South Texas Project
Units 3 and 4
Docket Nos. 52-012 and 52-013
Response to Request for Additional Information

RAI 07.01-15

RAI 07.01-15**QUESTION:**

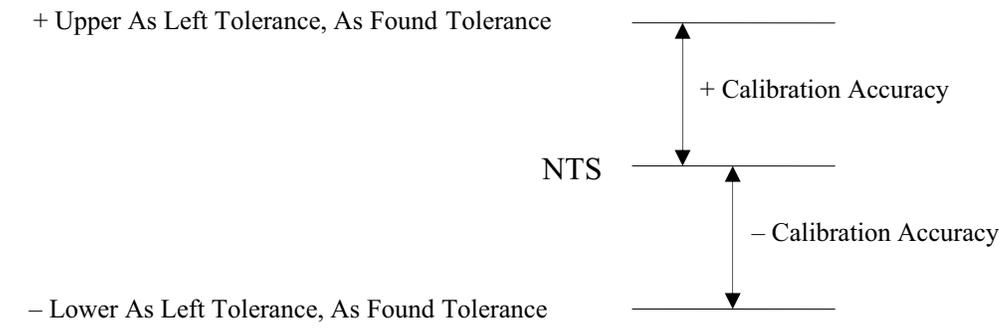
1. According to Figure 3-1 in WCAP-17119-P, the “as left” tolerance is same as the “as found” tolerance for the rack. Whereas Section 2.2, “Sensor Allowances” states that sensor calibration accuracy (SCA) is the difference between the “as left” value and the desired value, and Sensor drift (SD) is the difference between “as found” value and the “as left” value. Also as stated in Section 2.3, “Rack Allowances,” rack calibration accuracy (RCA) is the difference between the “as left value and the desired value, and Rack drift (RD) is the difference between the “as found” and “as left” values. The applicant is asked to resolve the above stated discrepancies and clarify whether the “as left” value is same as the “as found” value, and also provide a description for the desired value.

The following statement has been added to the end of the Nominal Trip Setpoint definition:

“Evaluations of as left and as found data for analog and digital process racks suggest rack drift (RD) is significantly smaller than the procedure allowed as left tolerance. Thus, the expectation that the rack module is found within the as left tolerance, and the definition of AFT =ALT, as noted below.”
